ADDENDUM NO. 1

Plans & Specifications for: Elsie Turner Field & Graverson Playground, Waltham, MA

In accordance with documents prepared by: Carolyn Cooney & Associates

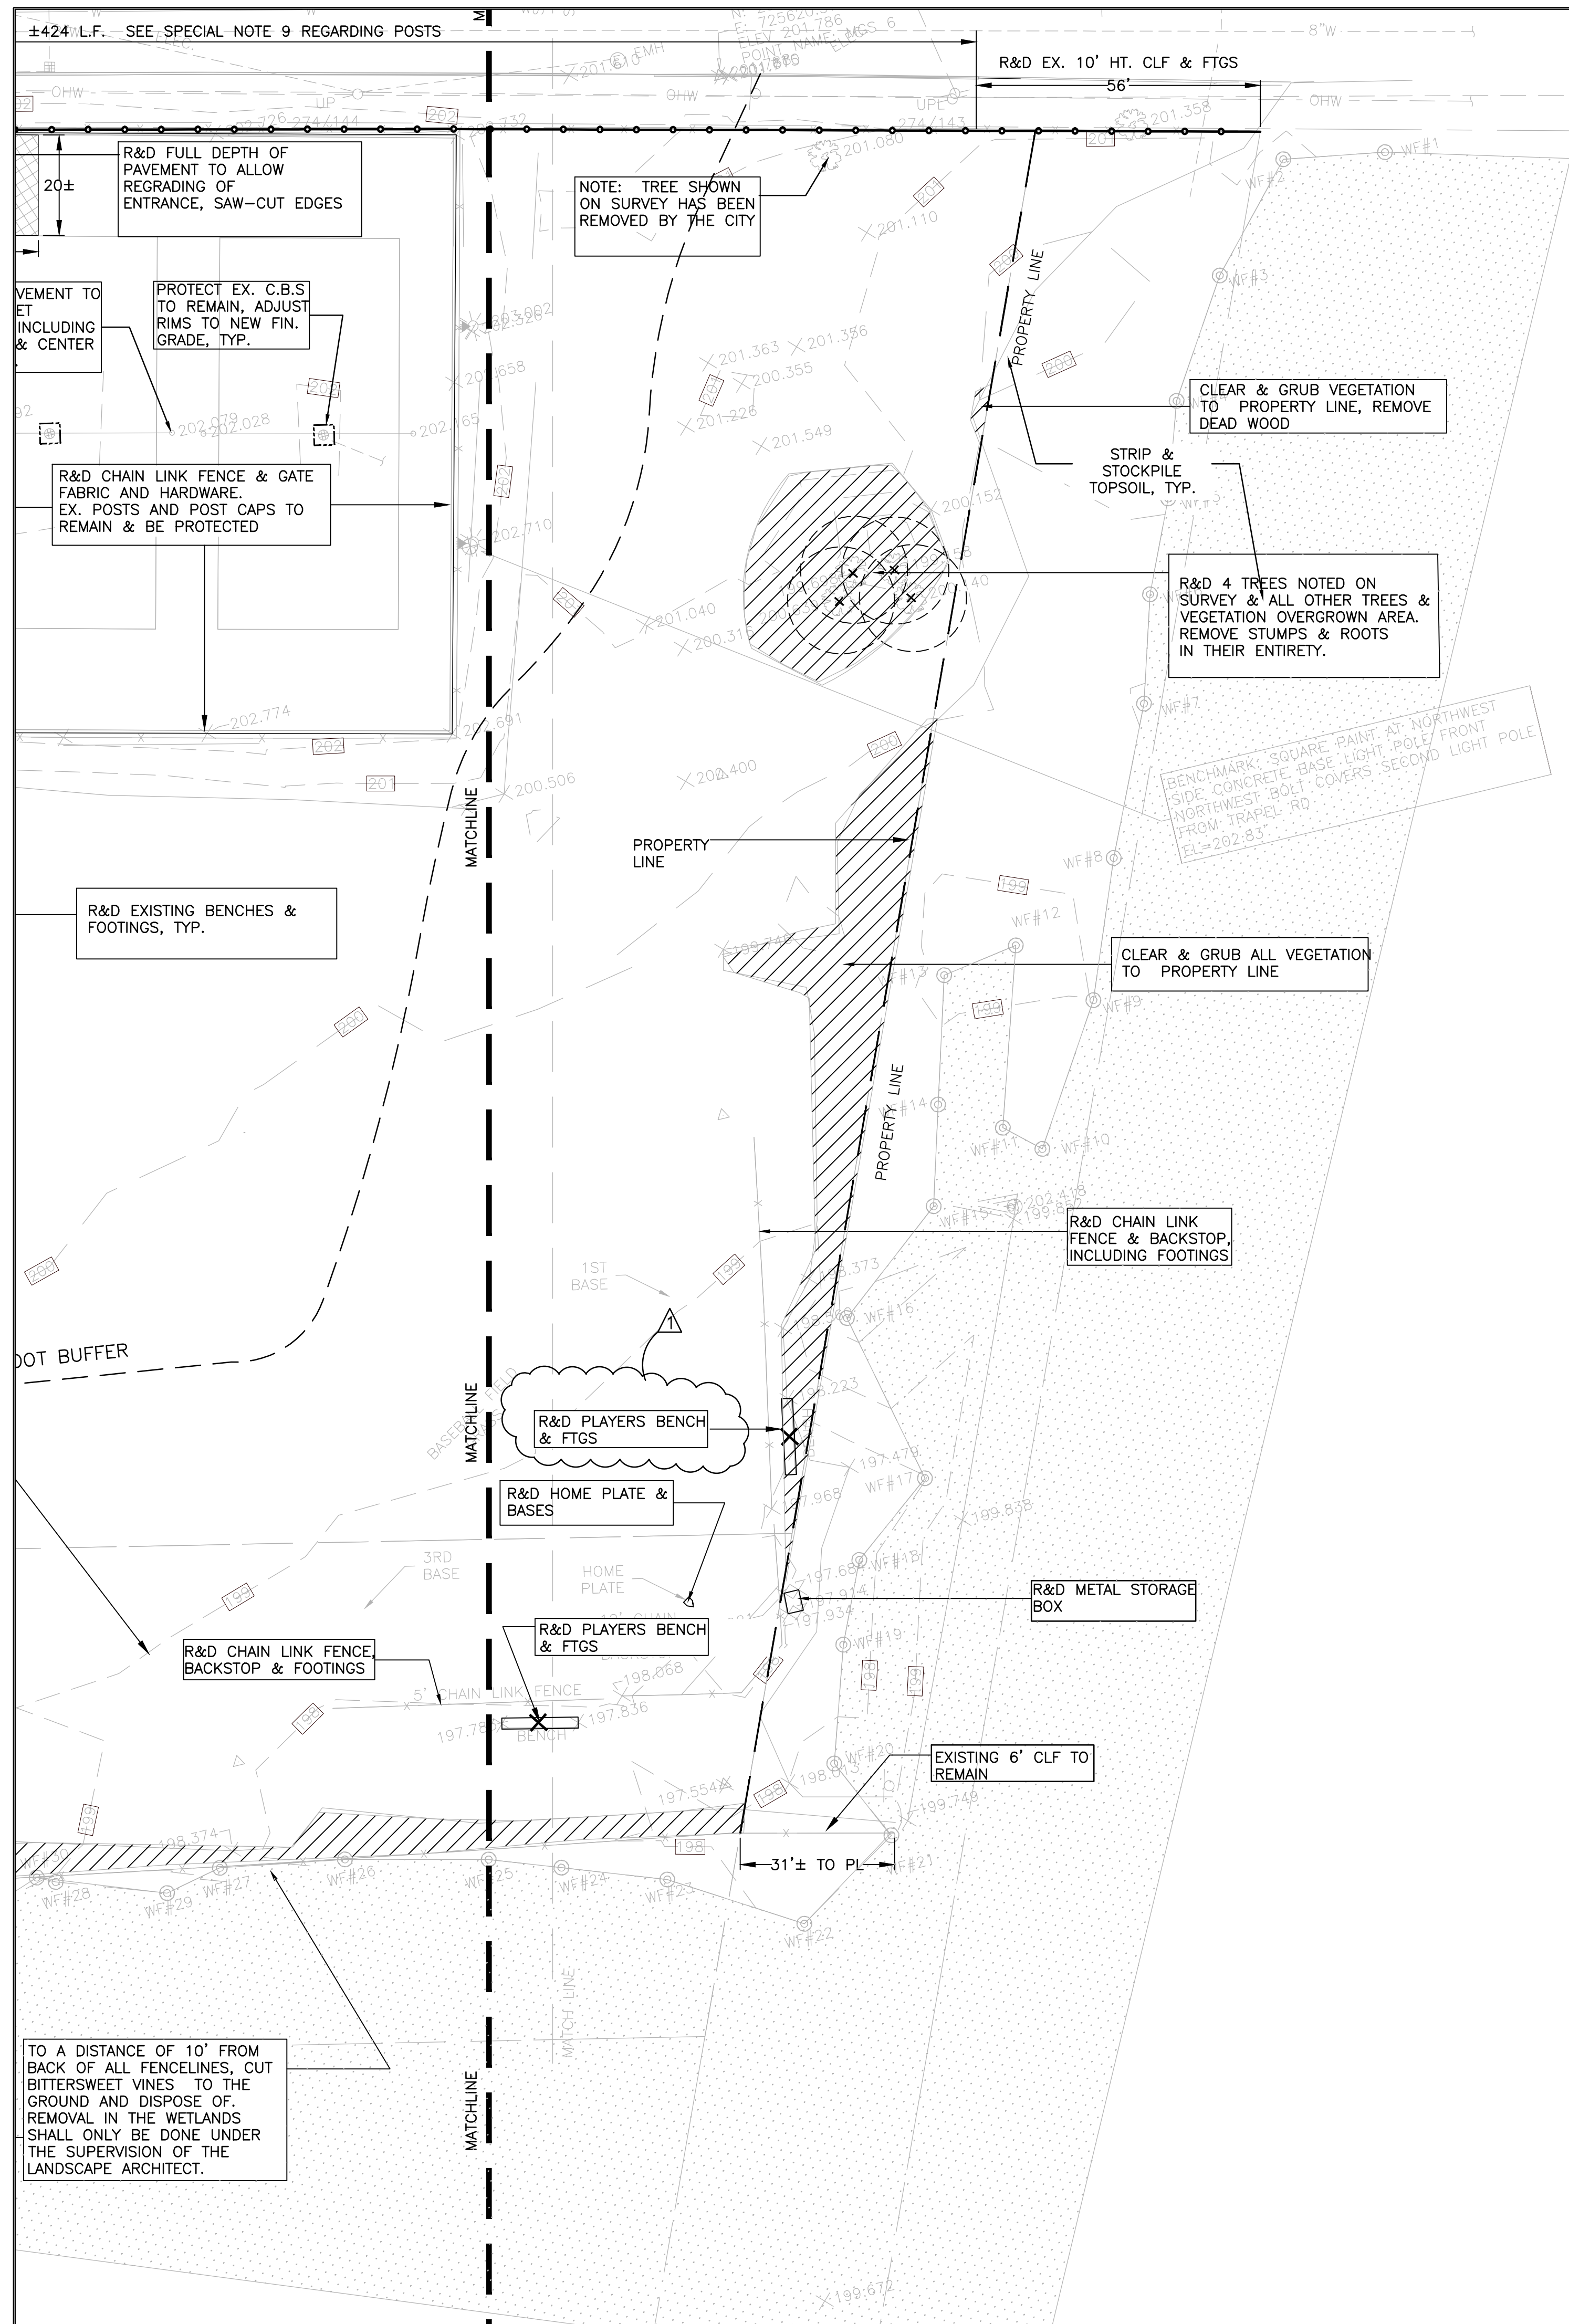
- ITEM NO. 5** *Graverson Playground: Replace Drawing L.102A with attached new Drawing
L.102A. Revision is to the Limit of Work Line.*
- ITEM NO. 6** *Graverson Playground: Replace Drawing L.102 with new Drawing L.102 attached.
Revision is to clarify that two player's benches and footings are to be demolished.*

ELEVATION
2 TENNIS BACKBOARDS (2 SETS OF 8' X 36')
SCALE: 1/4" = 1'

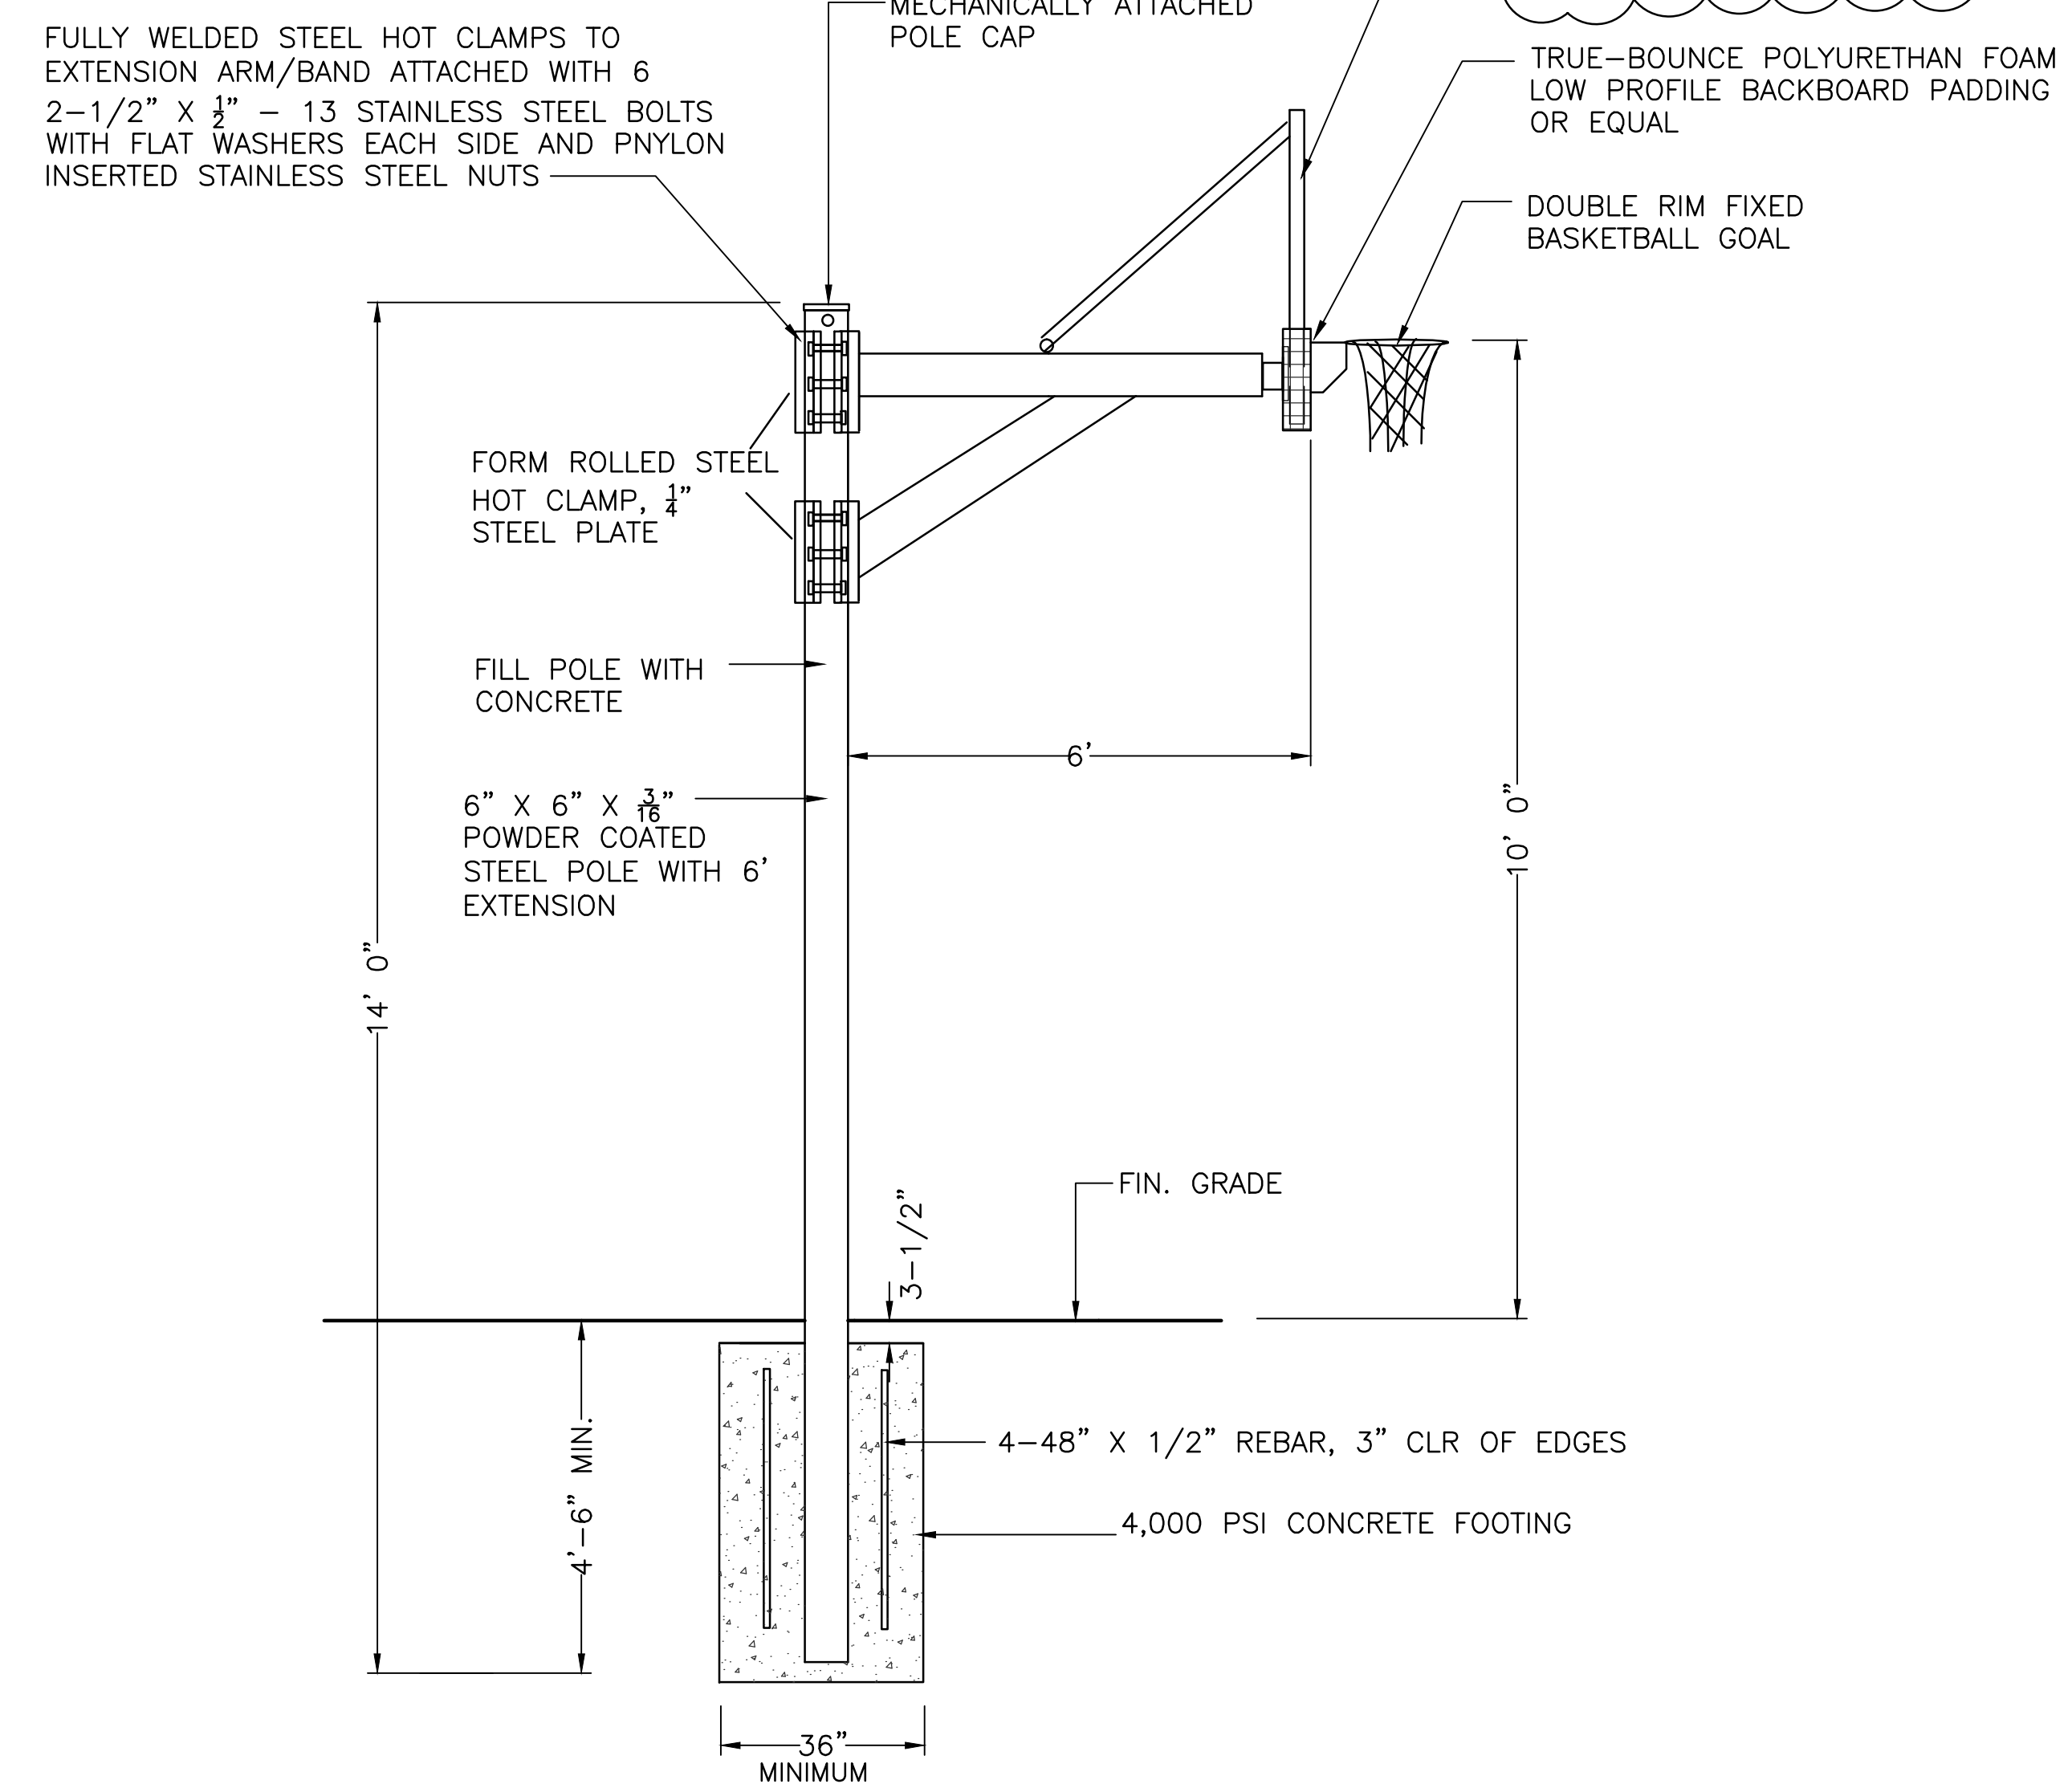
- ITEM NO. 7** *Graverson Playground: Replace Drawing L.613 with new Drawing L.613 attached.
Revision is to size of backboard.*
- ITEM NO. 8** *Graverson Playground: Replace Drawing L.625 with new Drawing L.625 attached.
Revision is to Drain Basin Detail.*
